Addendum No. 2

Subject: John M. Patterson Elementary School
2022 Classroom Modernization
SDP Contract Nos. 2022-010-G, 2022-010-P, 2022-010-E

Location: John M. Patterson Elementary School
7001 Buist Avenue
Philadelphia PA 19142

This Addendum No. 2, dated FEBRUARY 18, 2022, shall modify and become part of the proposed Contract Documents of the work of this project. Any items not mentioned herein, or affected by, shall be performed strictly in accordance with the original Contract Documents, unless modified by prior addenda.

1 ELECTRICAL FIRST FLOOR POWER NEW WORK PLAN
 SCALE: 1/8" = 1'-0"

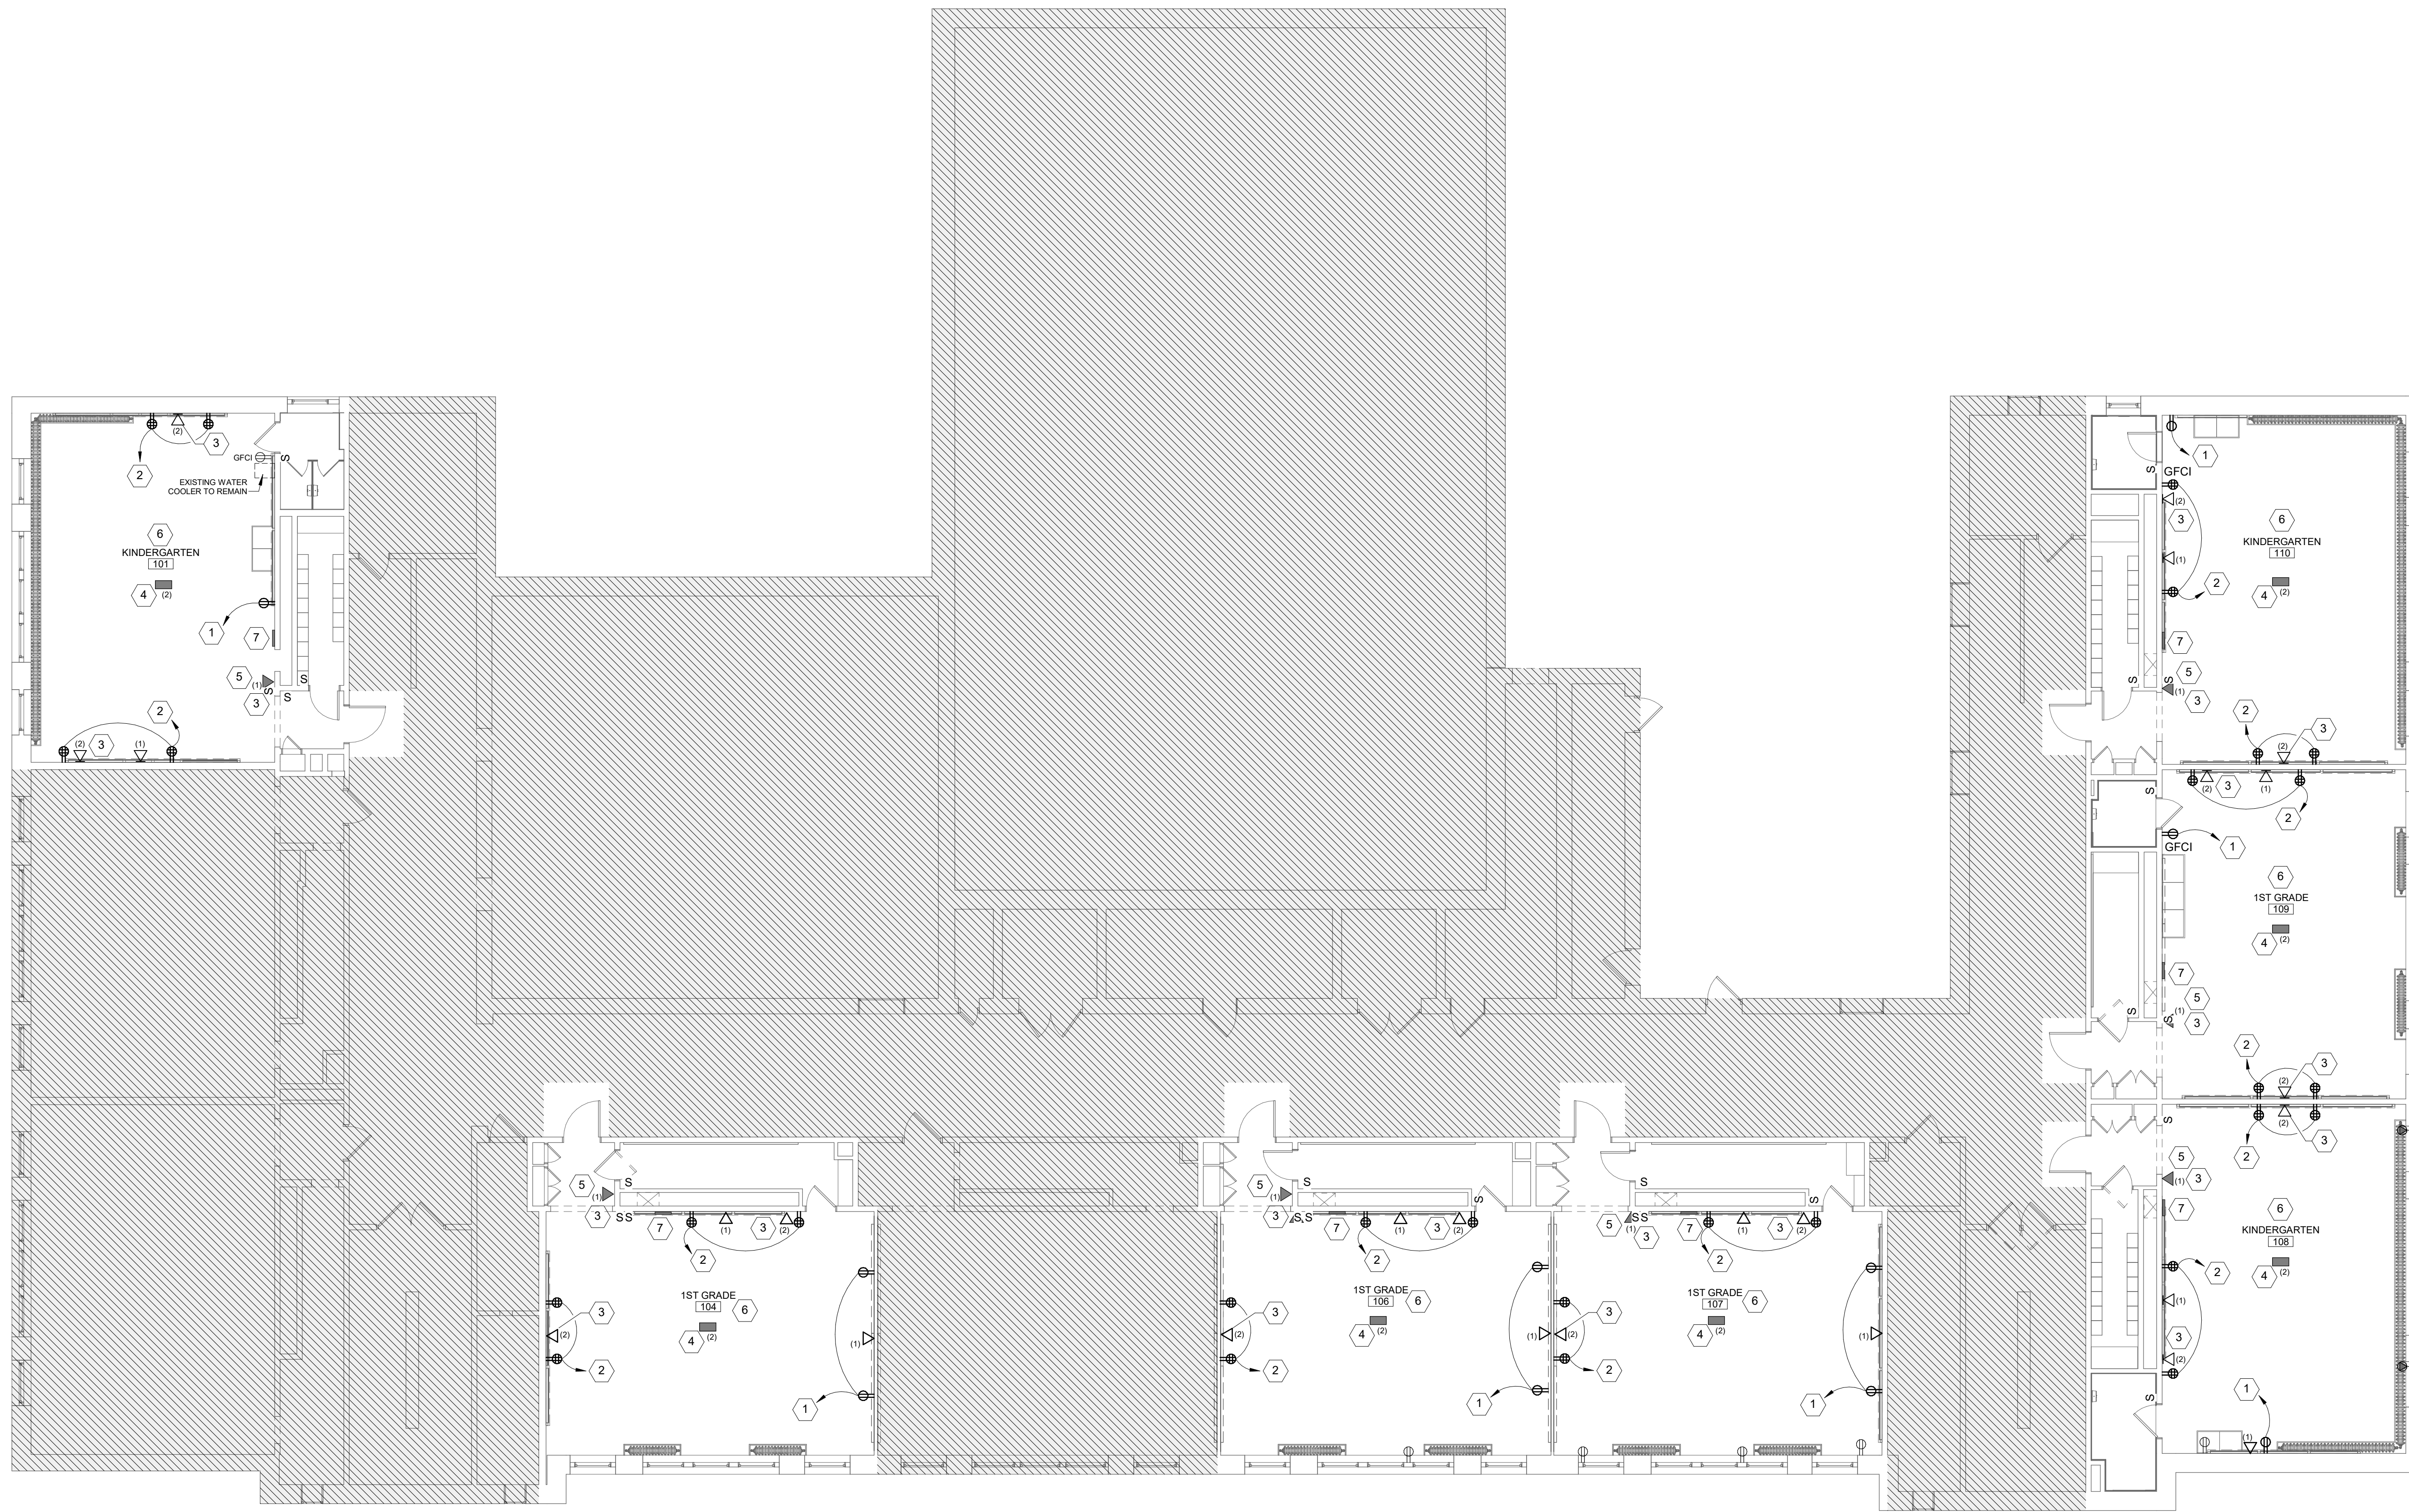
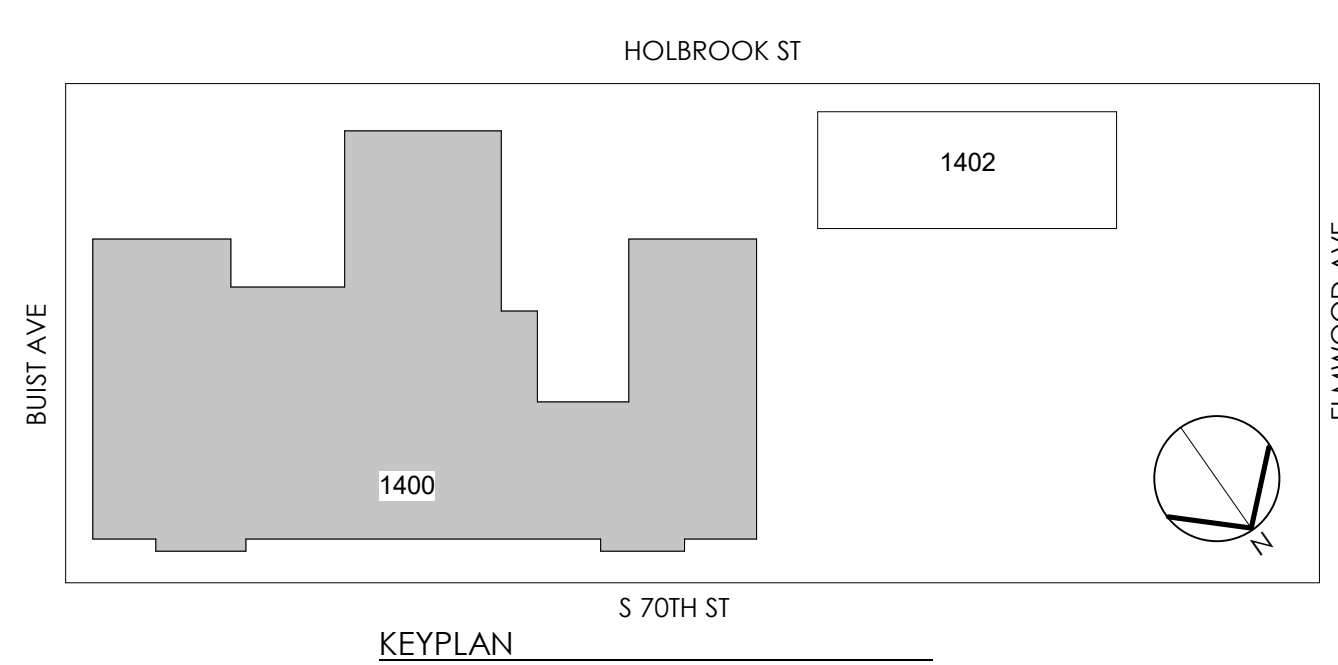
9. **Question:** Ref: Drawings E100, E101, E102, E103 SHEET KEYNOTE #3 - How do we bid "Provide new data outlets & Cat 6 cabling as needed"?

21. **Question:** Drawings E101/E102/E103/E100 new work keynotes #1 and #2 states to fish new wiring within partition walls, and that no surface mounted conduit is allowed in the annex. However, general note 3 on E101/E102/E103 says “paintable surface mounted conduit”, which conflicts with the first statement. Please confirm all new devices and new conduit can be surface mounted throughout the project, which has been typical for previous SDP projects.

Response: Provide new data outlets and wiring in main school building – see keynote #3 on revised E101, E102, and E103 attached. Existing data wiring to remain in annex building, replace receptacles and provide additional new outlets and wiring in locations noted – see revised E100 attached.

Response: At new (main building) and existing (Annex) drywall partitions, provide concealed wiring and recessed boxes for new electrical and data devices. At existing plaster walls (main building), painted surface-mounted EMT is acceptable. Refer to revised general note 3 on E100 series drawings.

DRAWING NO. E102

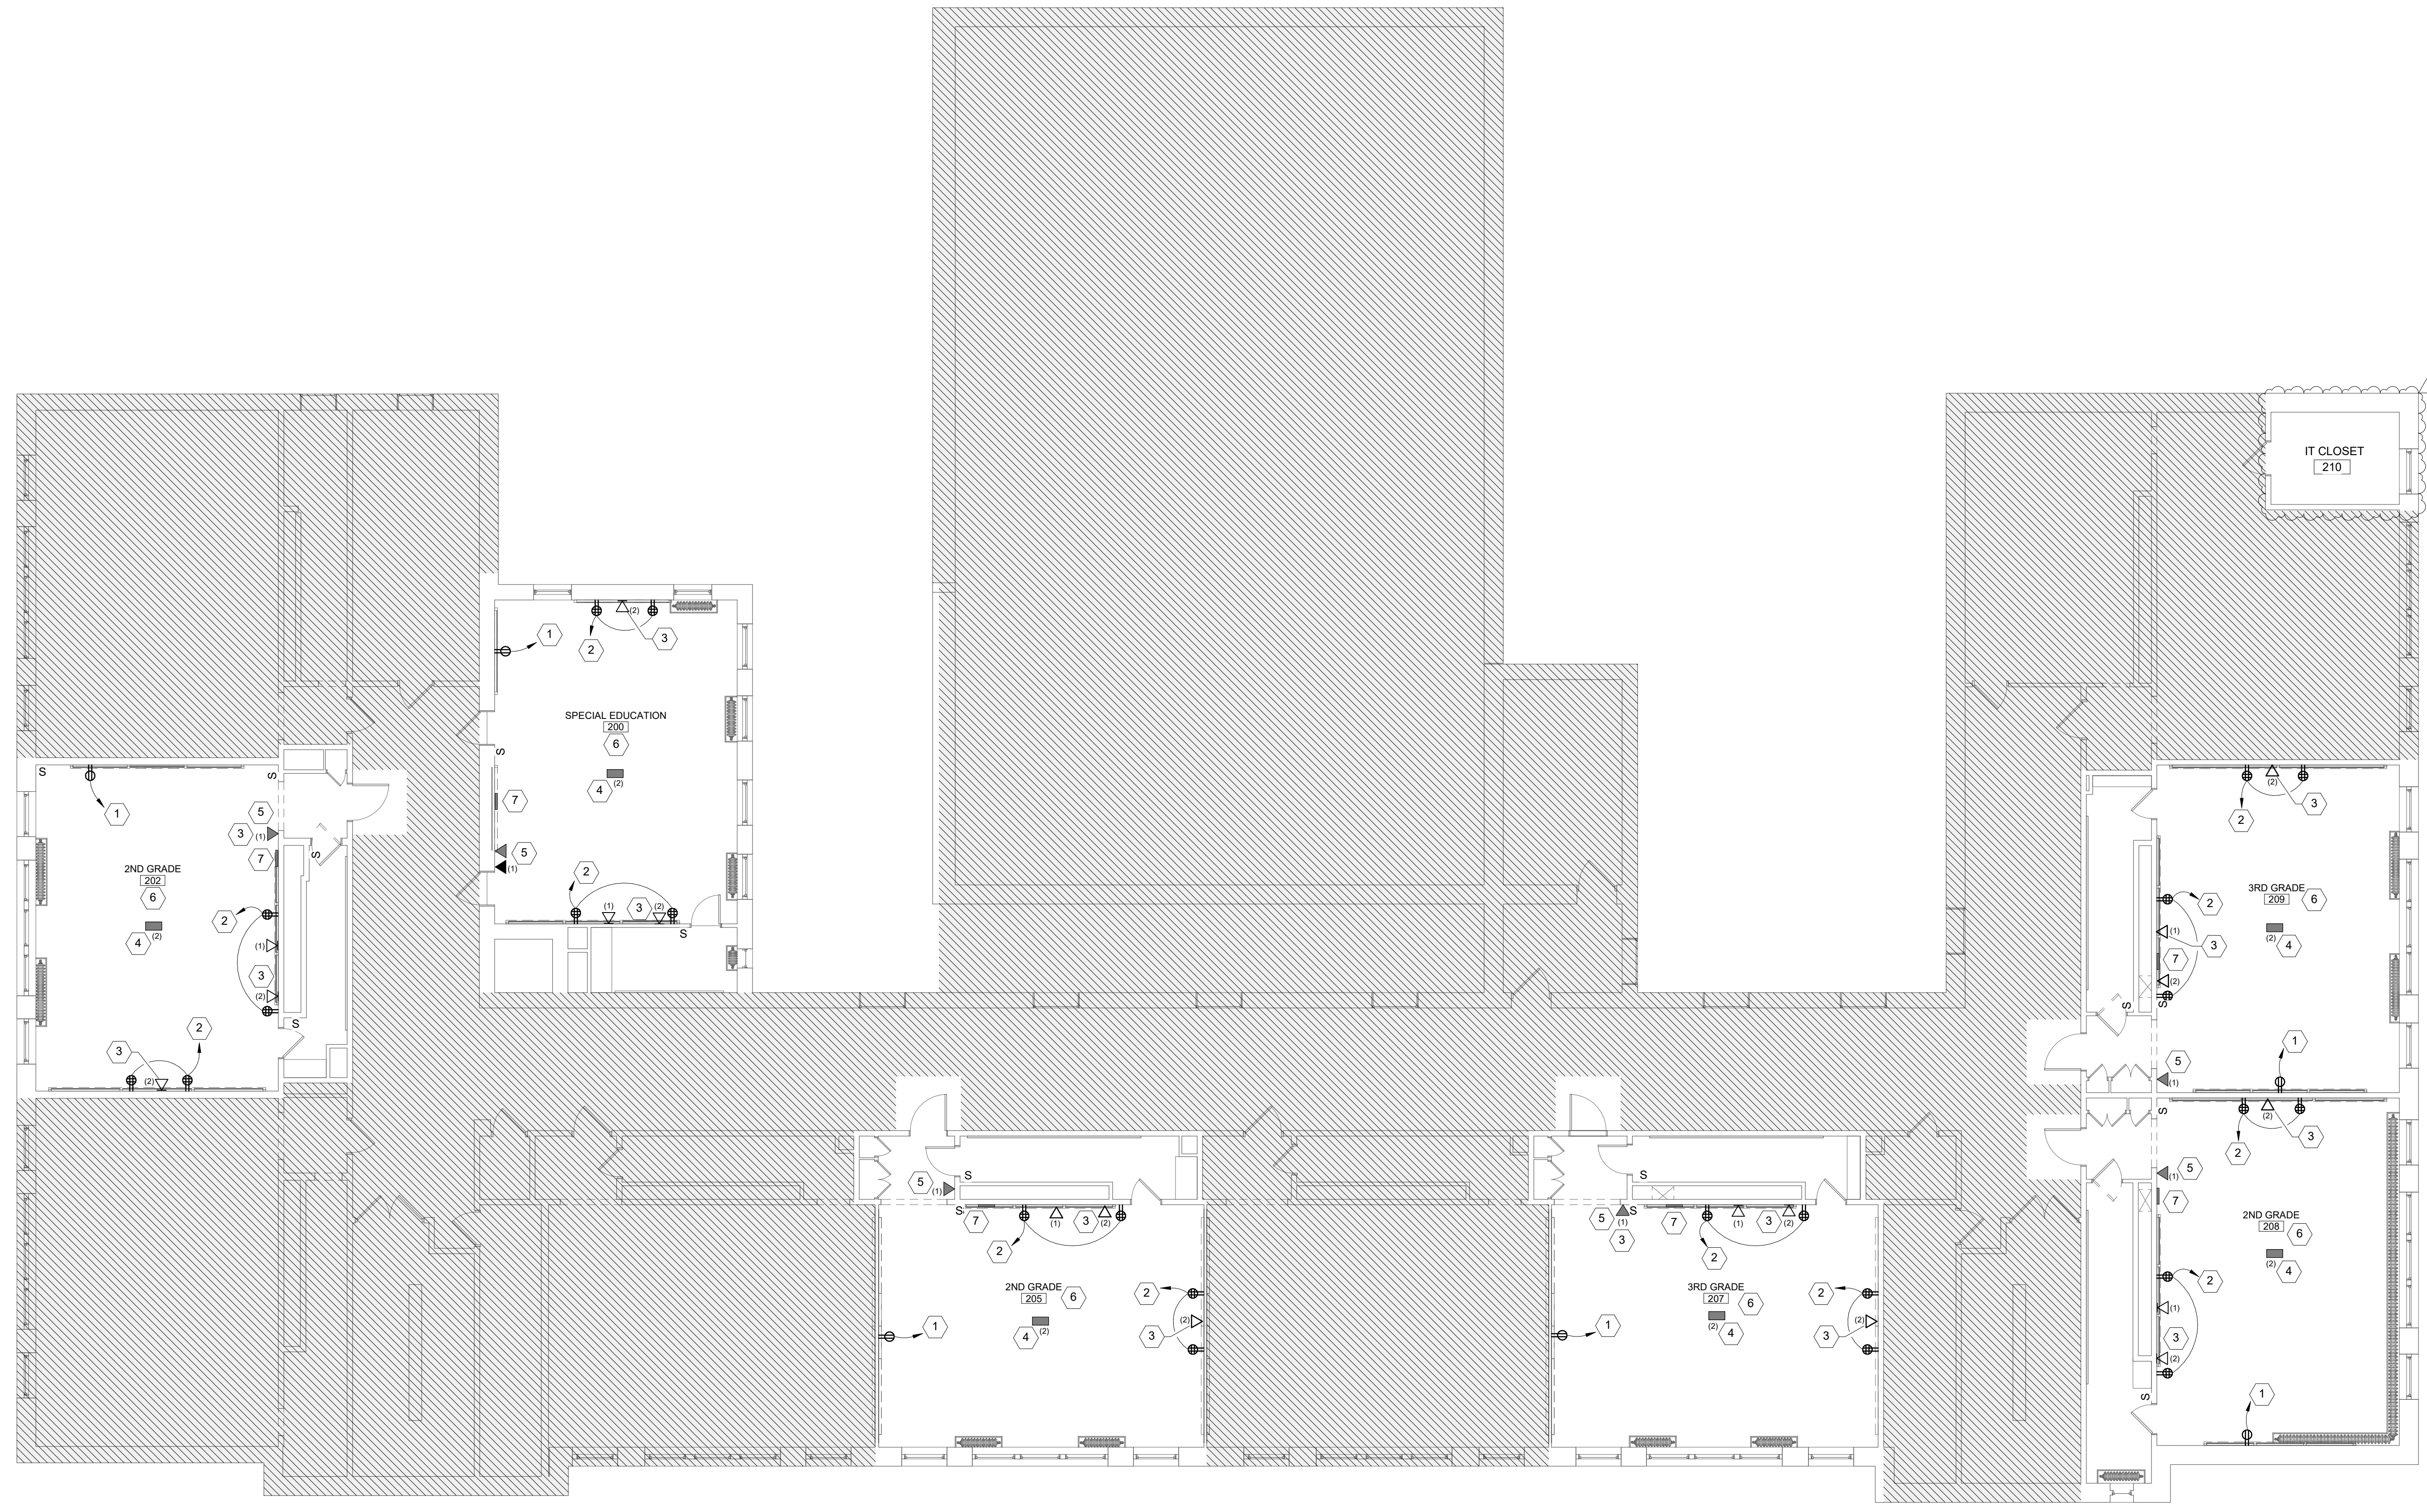
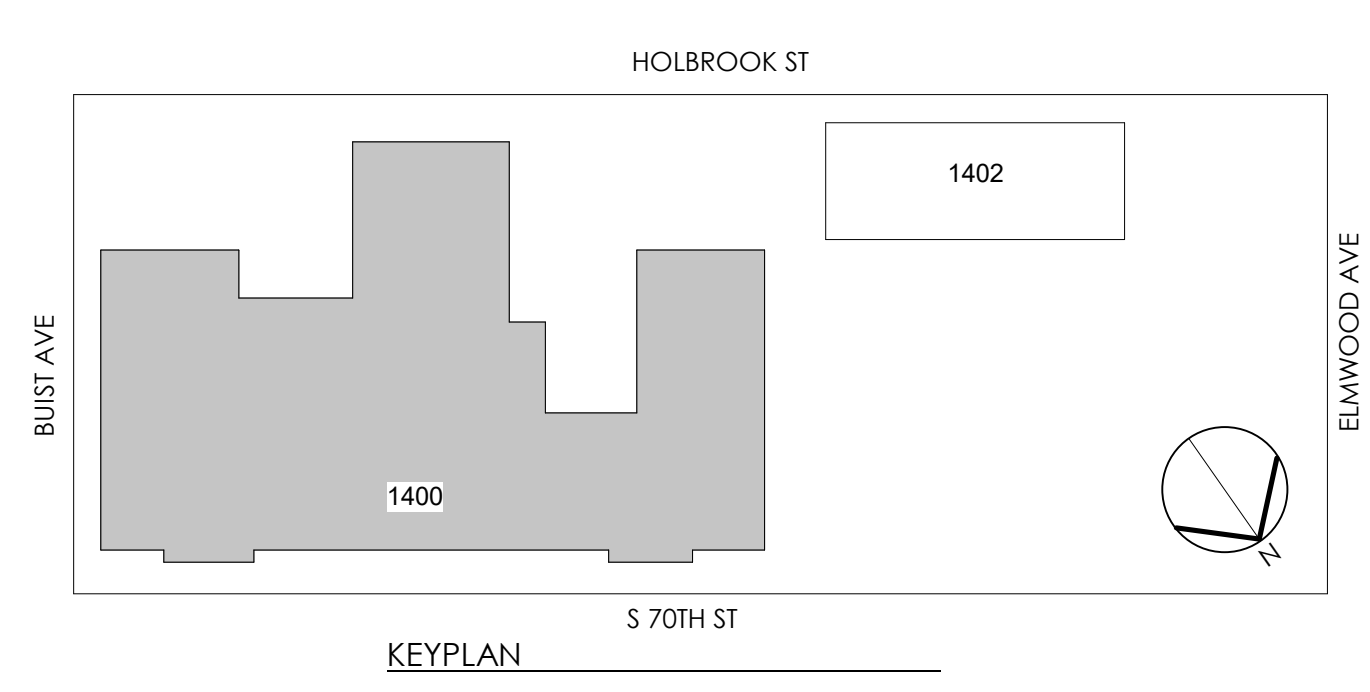
11. **Question:** Ref: Drawings E100, E101, E102, E103 SHEET KEYNOTE #3 - What is the location in the buildings for the MDF?

24. **Question:** Please provide the location in plan of the IT rooms where the new voice/data/WAP drops should be run to.

Response: Refer to revised E102 for IT Closet location in room 210.

Response: Refer to revised E102 for IT Closet location in room 210.
